Subject ▶ Changes on tool retainer and retainer sleeve

For Models ▶ HM1302, HM1303 (Demolition Hammers)

▶ Current	▶ New
Tool Retainer		
Retainer Sleeve

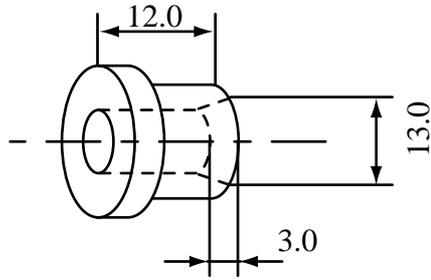
Description ▶ As illustrated below, two parts have been changed to improve strength of tool retainer.

Item No.	Current part	Q'ty	I/C	New part	Q'ty	Note
54	Tool Retainer 322831-0	1	No	Tool Retainer 322986-1	1	When you change tool retainer, please change as a set.
56	Retainer Sleeve 322832-8	1	<=	Retainer Sleeve 322987-9	1

Interchangeability mark; <= means that the new part can be substituted for the current.
